MANUAL CHANGES

Model Number: 8690B
Date Printed: May 1972
Part Number: 08690-90018

P/O Figure 7-3. Frequency Control Section Reciprocal Amplifier

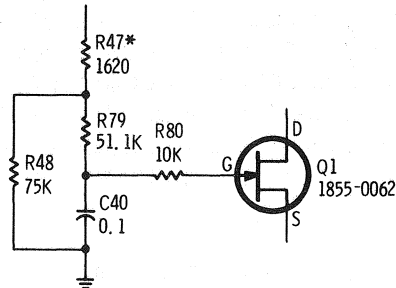
Change the circuitry of A3Q1 as shown in the attached drawing:

Component Identification, Assembly A9

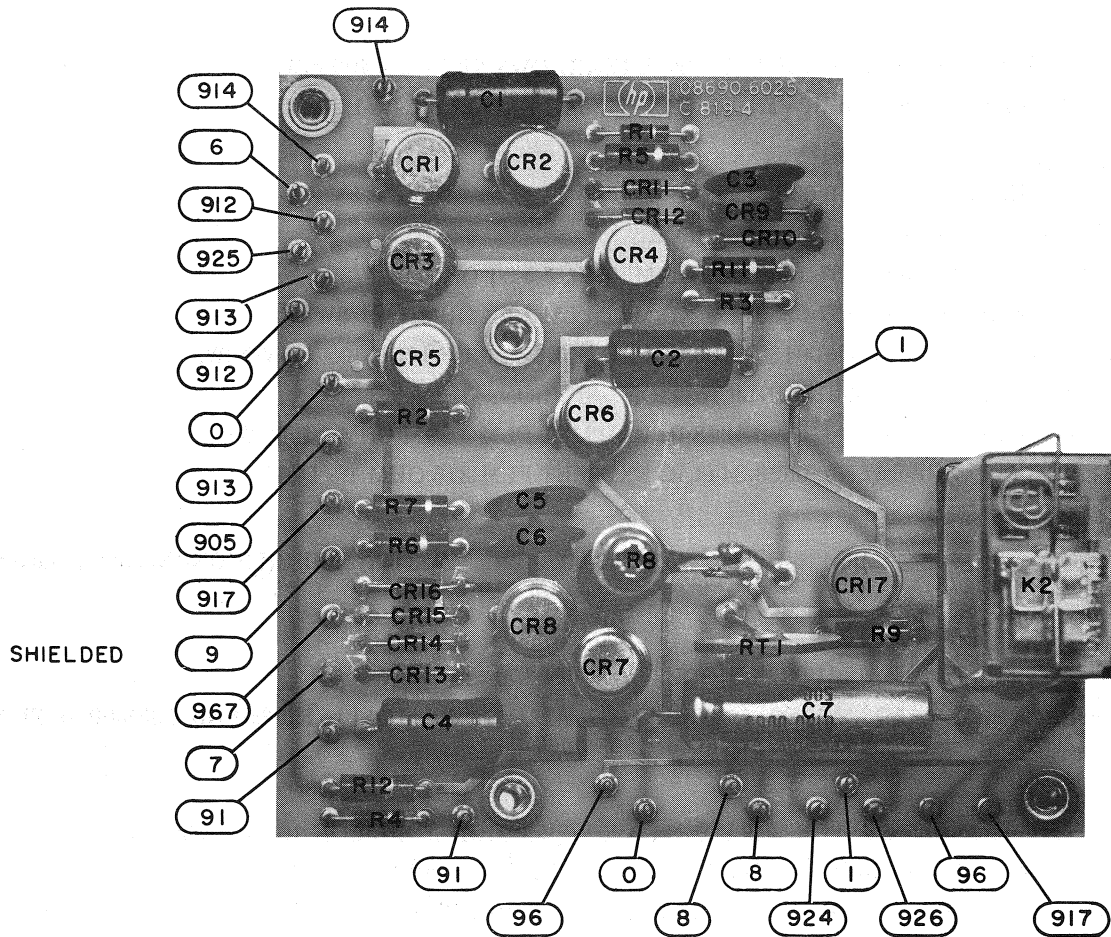
Page 7-14 and 7-16, Component Identification, Assembly A9:

Substitute the attached A9 Component Identification board for that shown in the 8690B Manual.

Figure 1. Component Identification, Assembly A8 (Part of Change 1)

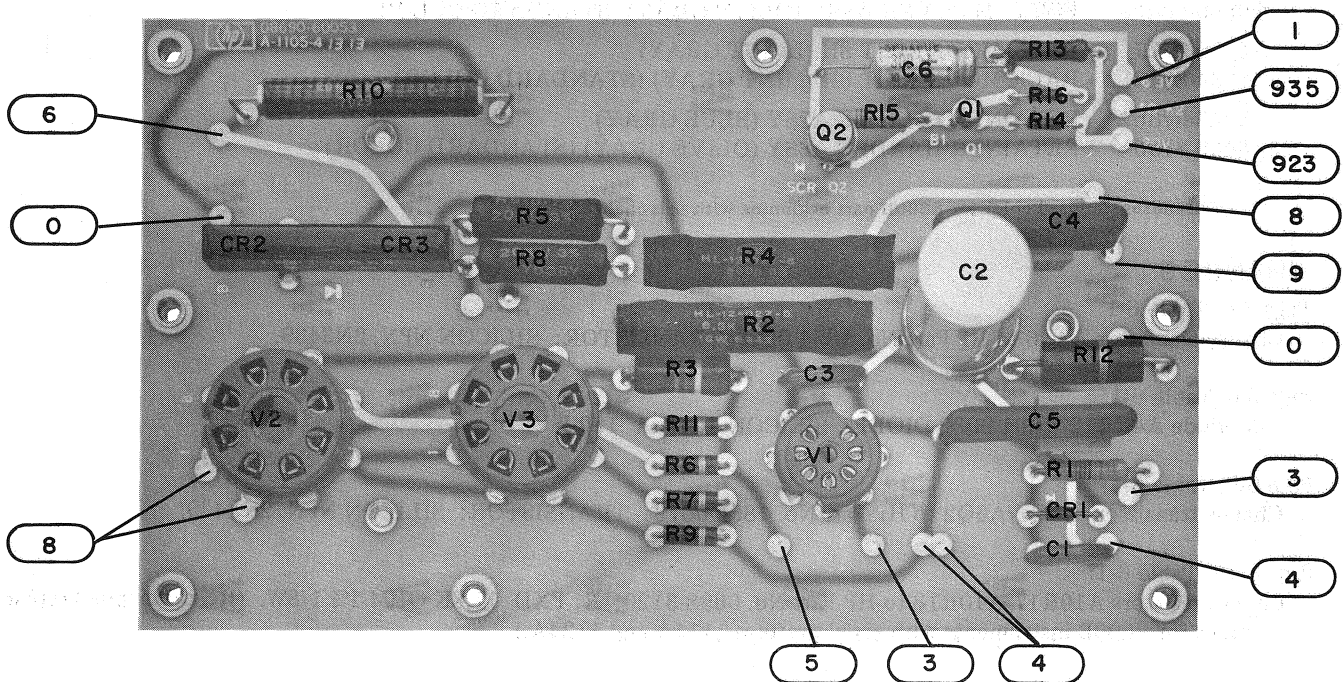
Page 7-14:

Substitute the attached A8 Assy, Component Identification board photo (Figure 1) for the photo shown in the 8690B Manual.

Figure 2. Component Identification, Assembly A14 (Part of Change 2)

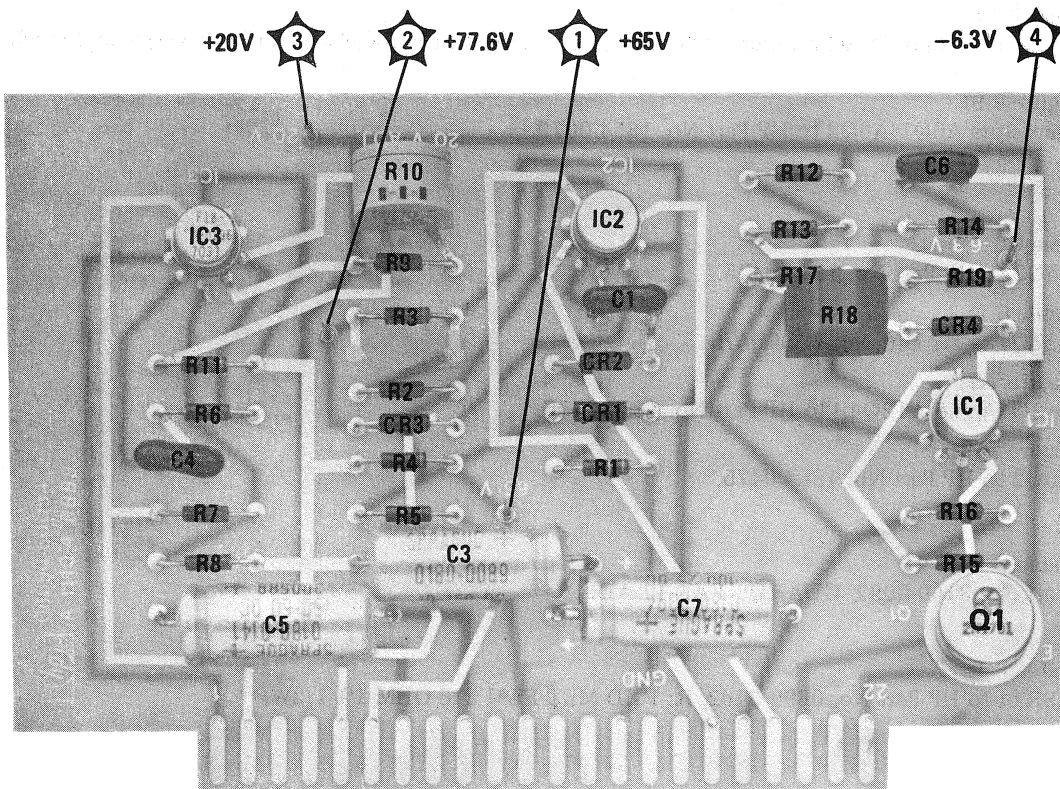
Page 7-14/7-15, Component Identification photo and Figure 7-8:

Substitute the attached A14 Assy board photo and schematic (Figures 2 and 3) for those shown in the 8690B Manual.

Figure 4. Component Identification, Assembly A4 (Part of Change 5)

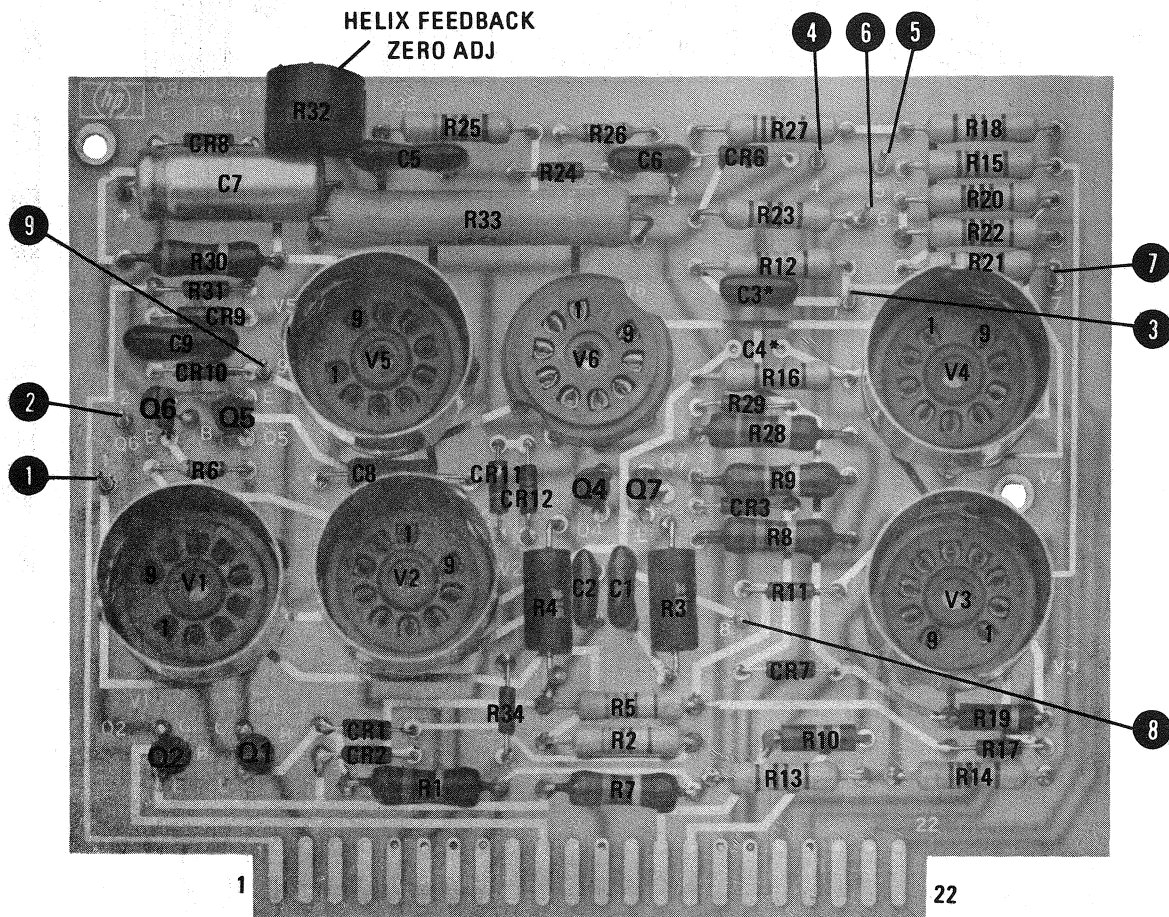
Add diode A4CR12 in series with zener diode A4CR11. Connect cathode of A4CR12 to ground, and anode to A4CR11.

Figure 5. Component Identification, Assembly A3 (Part of Change 1)

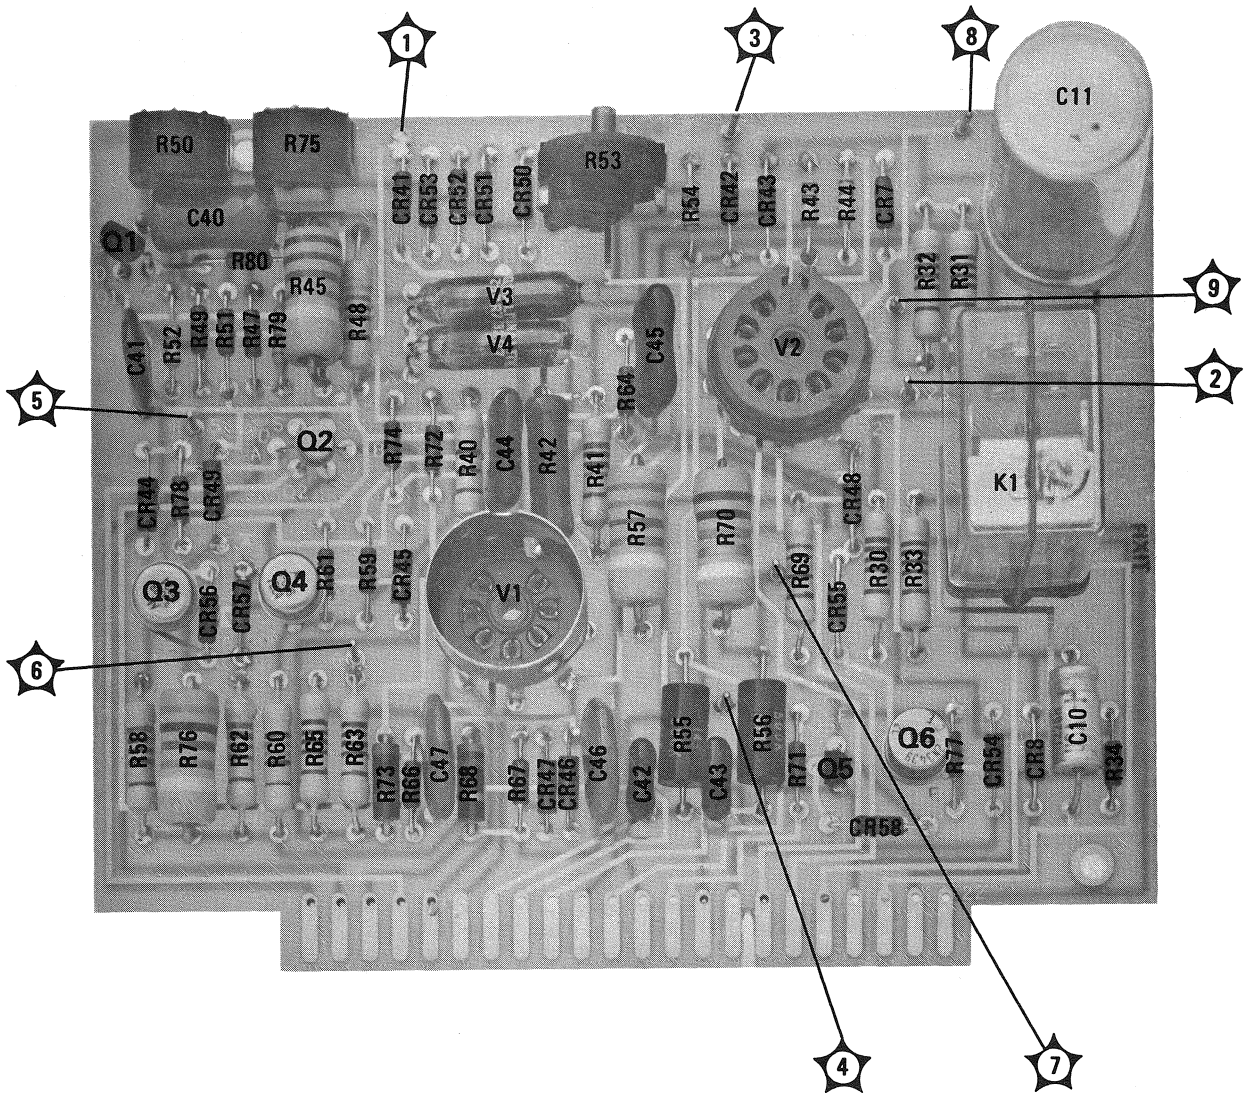
Substitute the attached Component Identification Assembly A3 board photo (Figure 5) for the photo shown in the manual.
